South Texas Project
Units 3 and 4
Docket Nos. 52-012 and 52-013
Supplemental Response to Request for Additional Information

RAI 03.07.01-27, Supplement 3**QUESTION:****Follow-up Question to RAI 03.07.01-19 (STP-NRC-100093)**

RAI 03.08.04-30 Supplement 2**QUESTION:****Follow-up to Question 03.08.04-23**

**Figure 3H.6-222a: Amplified N-S Site-Specific Response Spectra
Diesel Generator Fuel Oil Storage Vault (DGFOSV)**

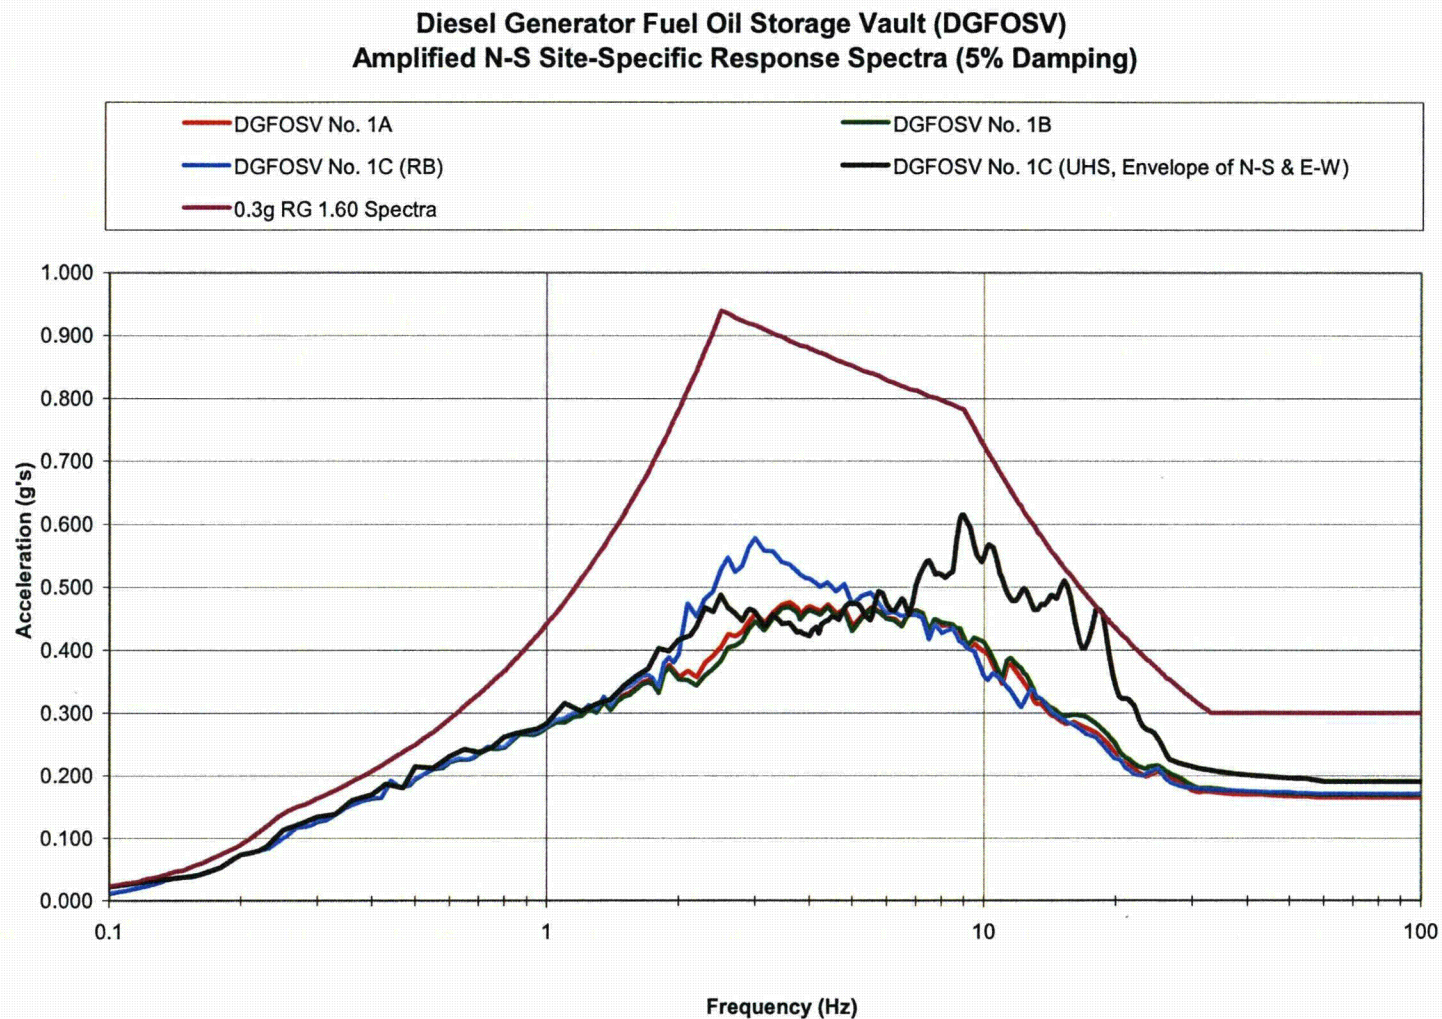
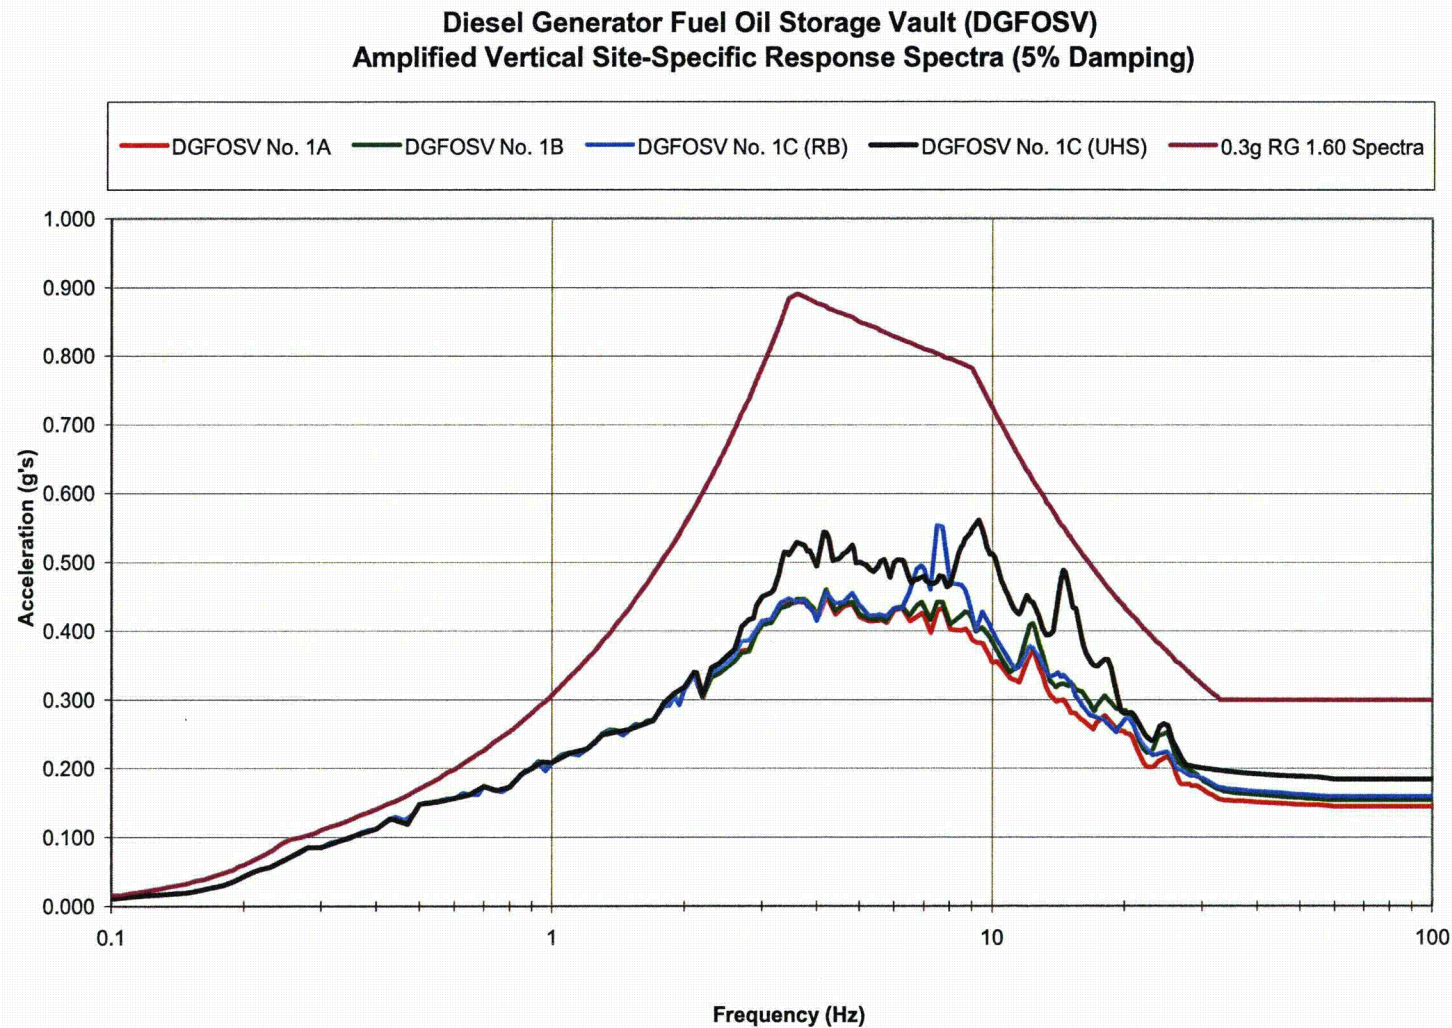
NINA was requested to provide a figure in COLA showing that 0.3g Regulatory Guide 1.60 spectra envelop amplified motions for all three vaults. (Audit Action Item 3.7-19)

Amplified site-specific response spectra of DGFOVS for 5% damping are provided in new COLA Figures 3H.6-222a, 3H.6-222b, and 3H.6-222c. As shown in these figures, the 0.3g Regulatory Guide 1.60 spectra, which were used for the SSI analysis, envelop the amplified site-specific response spectra.

As discussed in Item B above, new COLA figures 3H.6-222a, 3H.6-222b, and 3H.6-222c show that the 0.3g Regulatory Guide 1.60 spectra, which were used for the SSI analysis, envelop the amplified site-specific response spectra.
